Fox wood Garden Village

FOX WOOD GARDEN VILLAGE INDICATIVE ELE/SECTION STONE WALL - FINAL

DRAWING NUMBER 20285 IWE 04 I

Proposed Wall to tie in with Existing Coursing Bands as shown - NTS

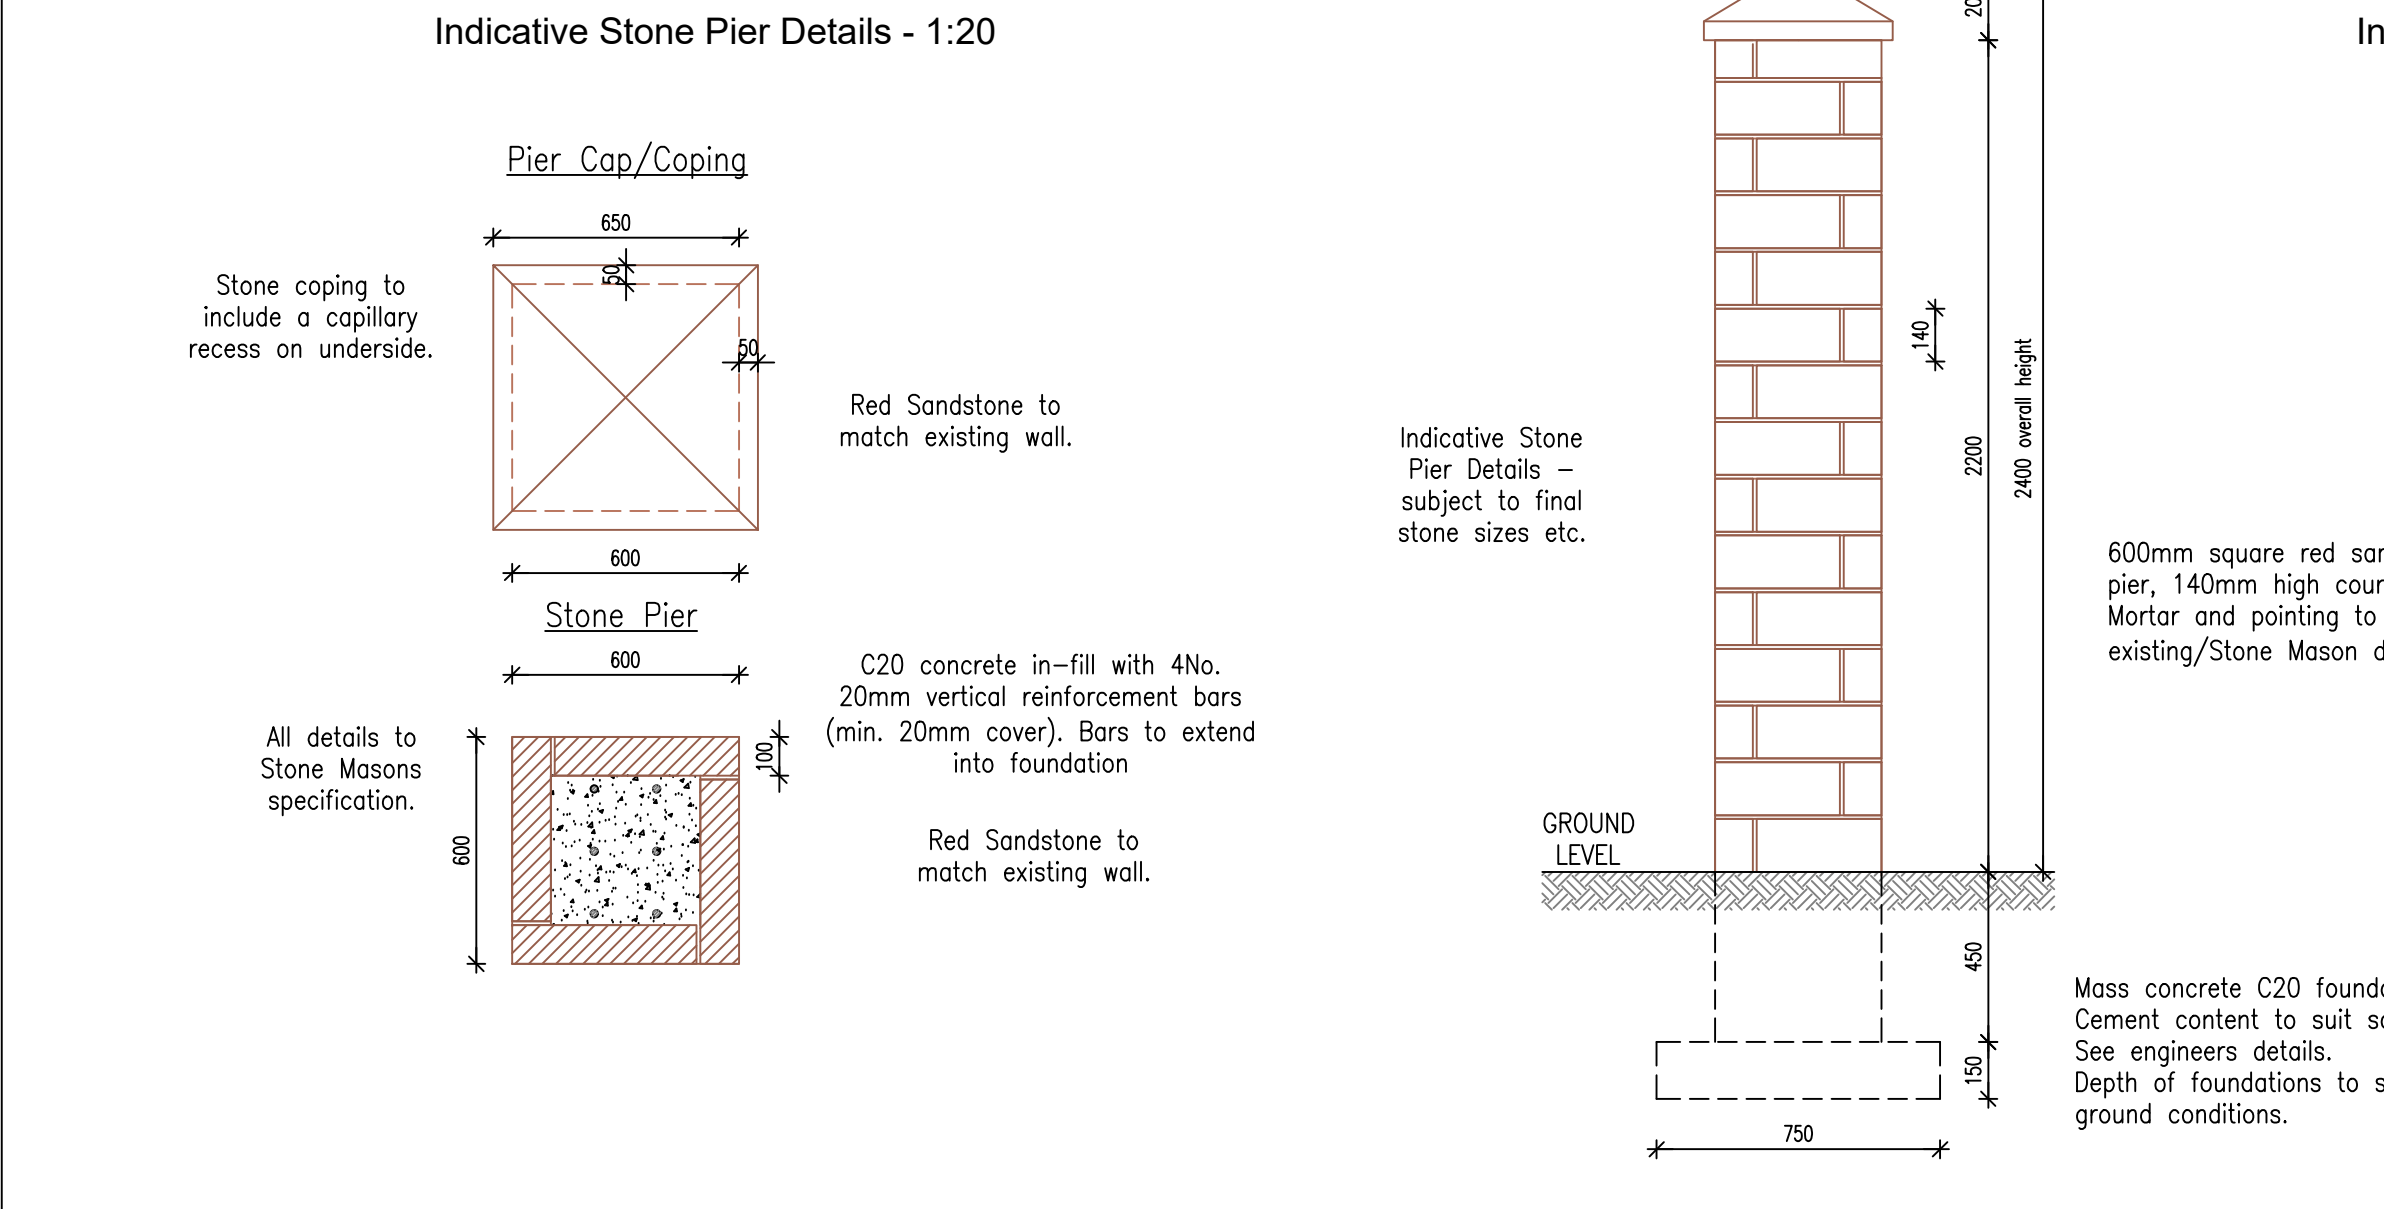
I	Sycamore tree removed from G13 on 2:1 policy due to Health & Safety concerns.	12/08/25	BB	
H	Following advice from TEP and approved by Clare Appleyard on 18/06/25, low level existing wall between J-K removed and replaced with mature hedge planting due to Health & Safety concerns regarding the proximity to existing tree and it's potential requirement for removal.	18/06/25	BB	
G	Following site visit with Clare Appleyard 05/06/25, scope revised fronting Plots 26 & 27 due to lack of existing stone wall.	05/06/25	BB	
F	Updated for clarity on height of rebuilt section A-B.	12/07/24	BB	
E	Revised in line with As Built section, specification updated to St. Bees and Point A buffer shown.	27/02/24	BB	
D	Revised in line with on site discussion with Stone Central & Knowlesy MBC to increase the pillar width to 600x250mm.	20/10/23	BB	
C	Revised in line with TEP's comments.	04/05/23	BB	
B	Revised in line with Planner's comments.	09/03/23	BB
